UNITED STATES PATENT AND TRADEMARK OFFICE

APPLICATION NO.	FILING DATE	FIRST NAMED INVENTOR	ATTORNEY DOCKET NO.	CONFIRMATION NO.
10/791,870	03/04/2004	Yoshio Ozawa	04329.3260	5239
22852 75	90 06/23/2005		EXAMINER	
FINNEGAN, HENDERSON, FARABOW, GARRETT & DUNNER			но, ти ти v	
LLP 901 NEW YOR	K AVENUE, NW		ART UNIT	PAPER NUMBER
WASHINGTON, DC 20001-4413			2818	
			D. TE. 14.11 ED. 04 M2 M004

DETAILED ACTION

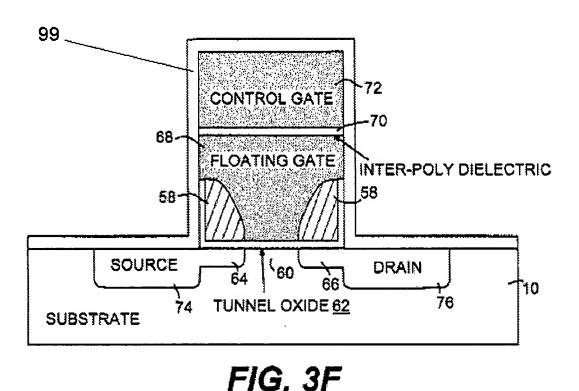
Referring to claims 1 and 4, the '904 reference discloses in Figures 3's, particularly Fig. 3F, and respective portions of the specification a nonvolatile semiconductor memory cell comprising:

a stacked-gate structure that includes a tunnel insulation film (62, column 3, line 42), a floating gate electrode (68), an inter-electrode insulation film (70) and a control gate electrode (72), which are stacked on the semiconductor substrate; and

gate side-wall insulation films (58/99) formed on both side surfaces of the stacked-gate structure,

wherein the thickness of the gate side-wall insulation film (58/99) increases, at a side portion of the floating gate electrode, from the inter-electrode insulation film (70) side toward the tunnel insulation film side, and the width of the floating gate electrode in a channel length direction decreases from the inter-electrode insulation film side toward the tunnel insulation film side.

Note: 99 is added by the examiner for ease of explanation.

Referring to claim 5, the '904 reference further discloses that the gate side-wall insulation films (58/99) comprises a first side-wall insulation film (58) that is provided on a side surface of the floating gate electrode (68), and a second side-wall insulation film (99) that is provided on a side surface of the control gate electrode (72).

Referring to claim 3, as is evident for Fig. 3F, the inter-electrode insulation film (70) has a substantially flat structure, and an area of the tunnel insulation film, which contacts the floating gate electrode (68), is about 70% or less of an area of the inter-electrode insulation film, which contacts the floating gate electrode.
